# 6<sup>th</sup> Street Active Transportation Bridge

COMOX VALLEY CYCLING COALITION

PRESENTATION TO COURTENAY CITY COUNCIL

JANUARY 18, 2021

## User Forecast Comparison

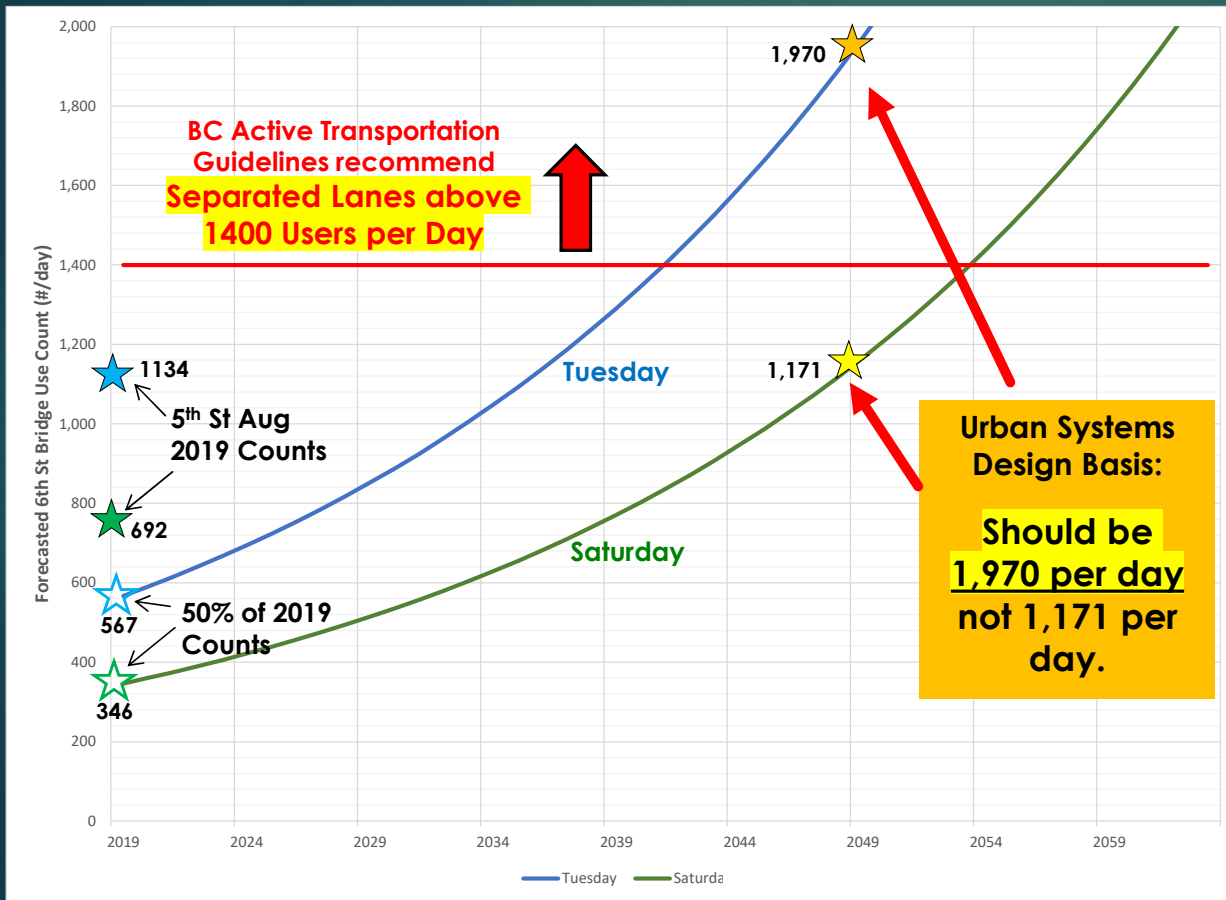
- Chose to use the 5<sup>th</sup> St data from the Saturday count which was the **lowest of the two samples**
- Only used a **30 year window** (to 2049) when the **life span of the bridge is 75 years**
- As the graph shows, even using the 50% uptake and slow growth assumptions **suggests that the bridge must be built to support separated lanes (4.8m minimum) sometime in the first 30-40% of its life span**

## Current Design – West Side – 4.0m Bridge Width

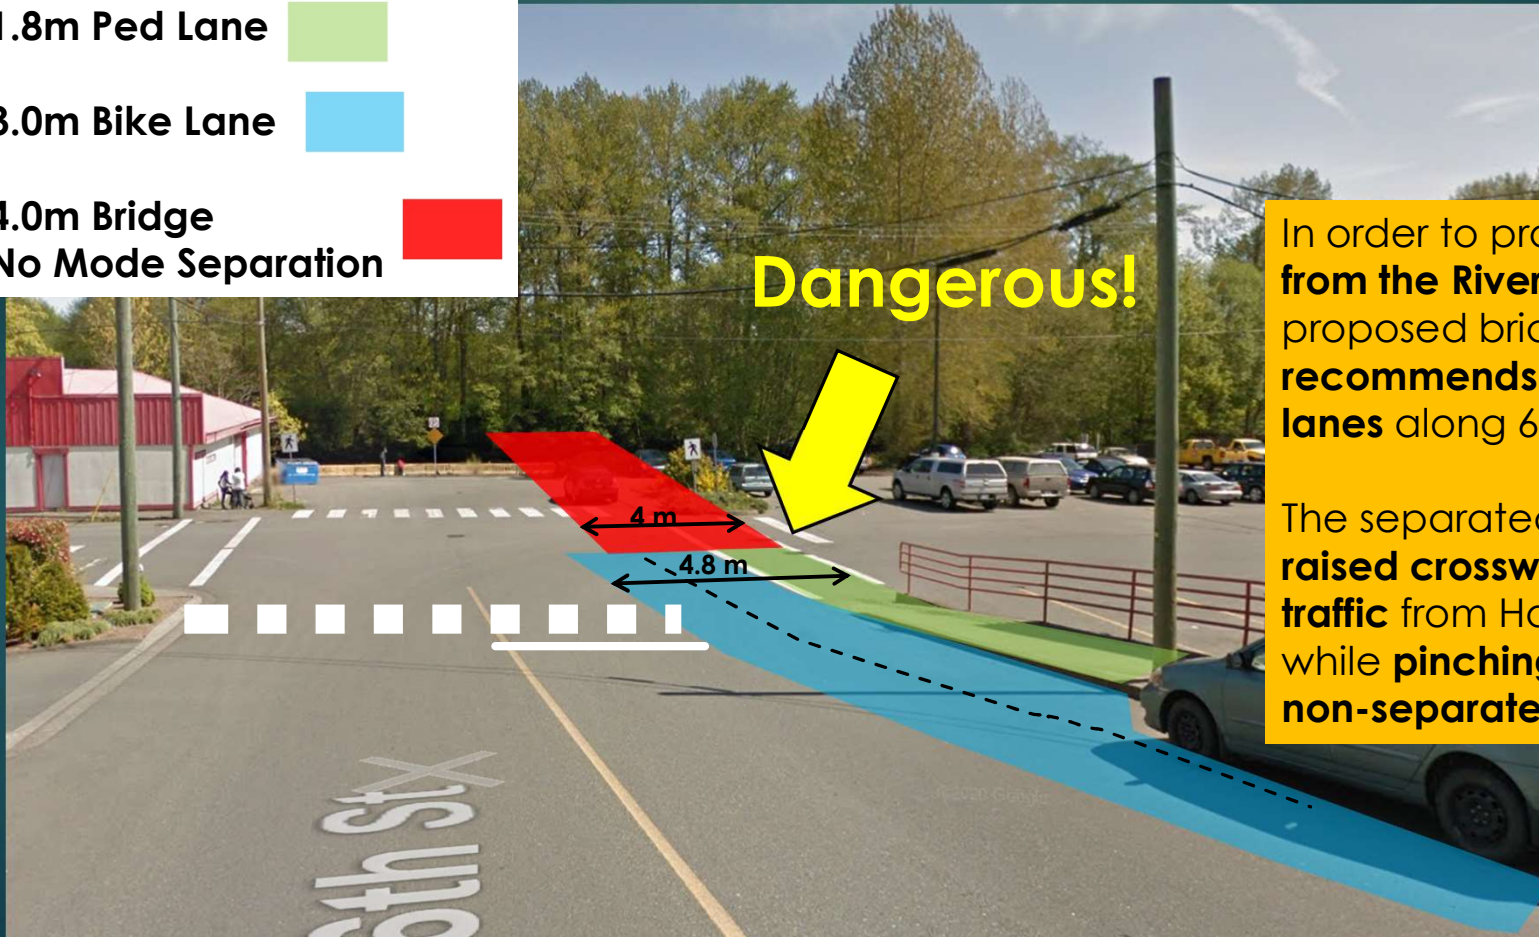
4.0m Bridge  
No Mode Separation

In order to provide a **safe corridor** from the Riverway Path to the proposed bridge, V+M recommends **separated bike/ped lanes** along 6<sup>th</sup> St hill.

The separated lanes meet a **new raised crosswalk and parking lot traffic** from Home Hardware all while **pinching onto a narrower, non-separated bridge deck...**

## West Side (with 4.8m Bridge Width)

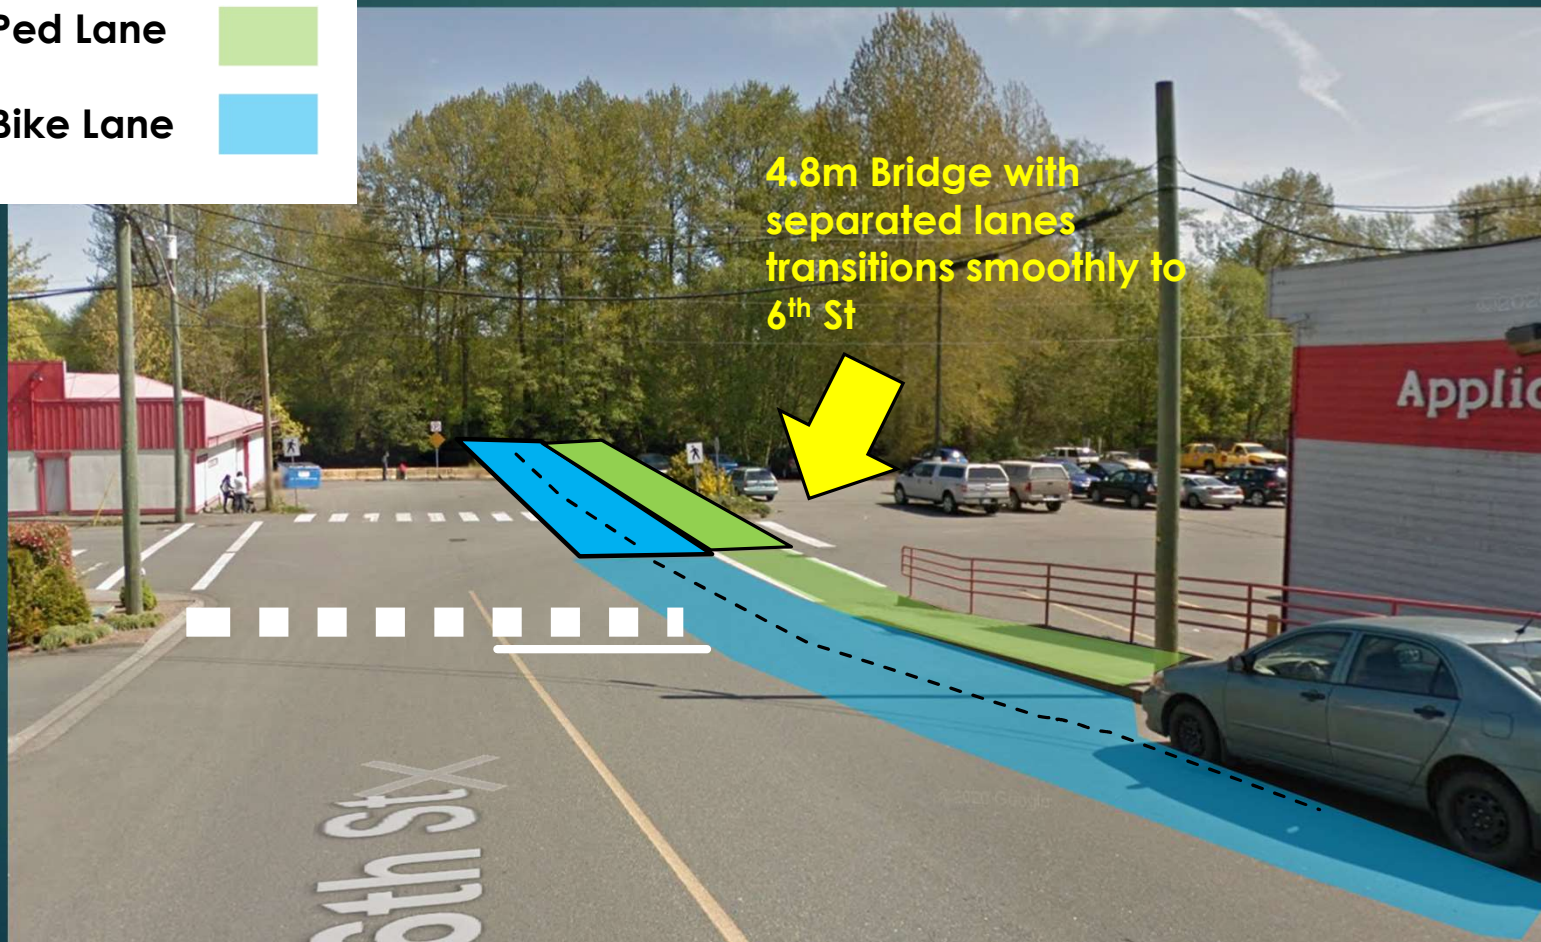
4.8m Bridge with  
separated lanes  
transitions smoothly to  
6<sup>th</sup> St

**Separated** bike  
and pedestrian  
**lanes** down 6<sup>th</sup> St  
**match up** with  
separated lanes  
on a **4.8m wide**  
**bridge deck**
